April 21, 2008

Re: Beneficial Use Field Exam Review Comments, Permits 63-12569, 63-31261, 65-13933

WELL # 2

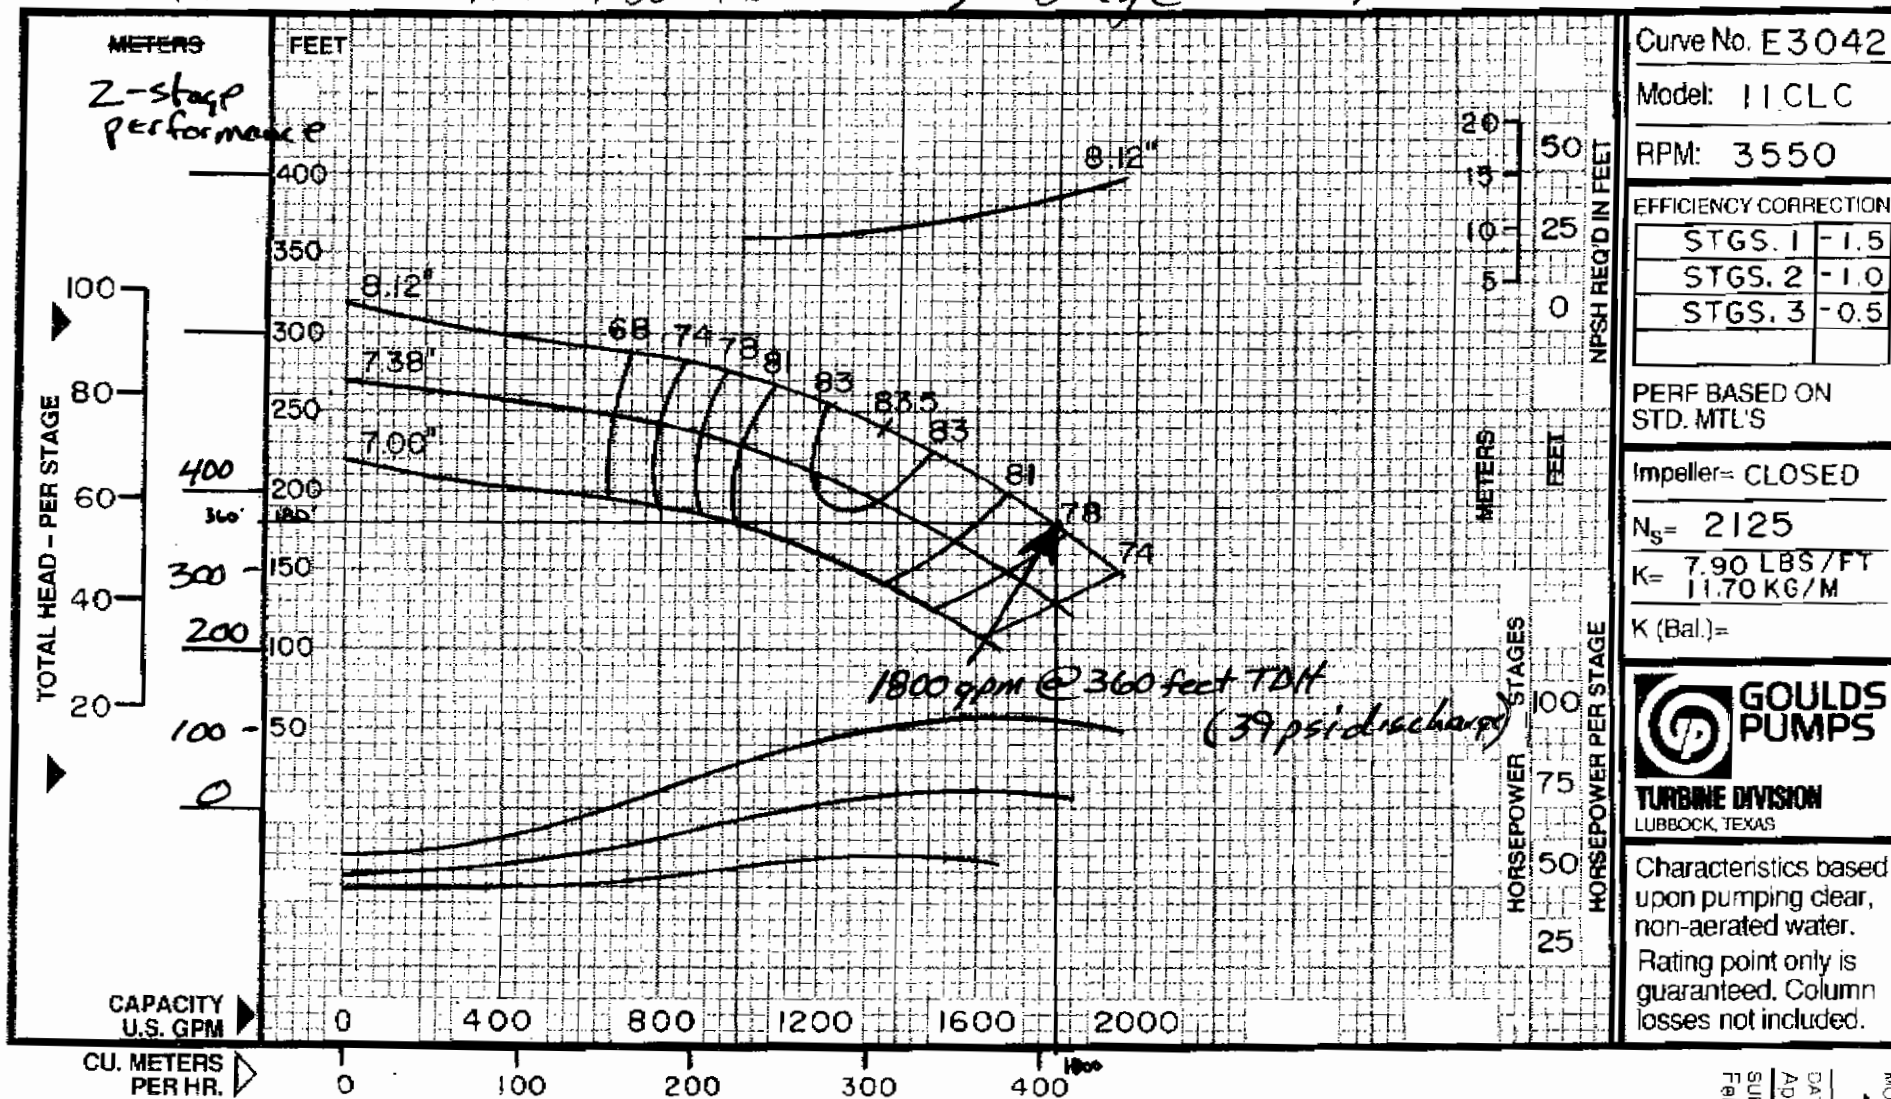
Pump Capacity. The supplied pump curve shows 1800 gpm at 180 feet per stage. The pump has two stages, therefore it should produce 180 gpm at 360 feet TDH (i.e., 2 times 180 feet).

ASSUMES LINEAR RELATIONSHIP &

DRAWDOWN IS
EXPONENTIAL

See attached performance curve with requested information indicated.

1300 GPM AT 480 TDH 2 Stage Pump set AT 350'
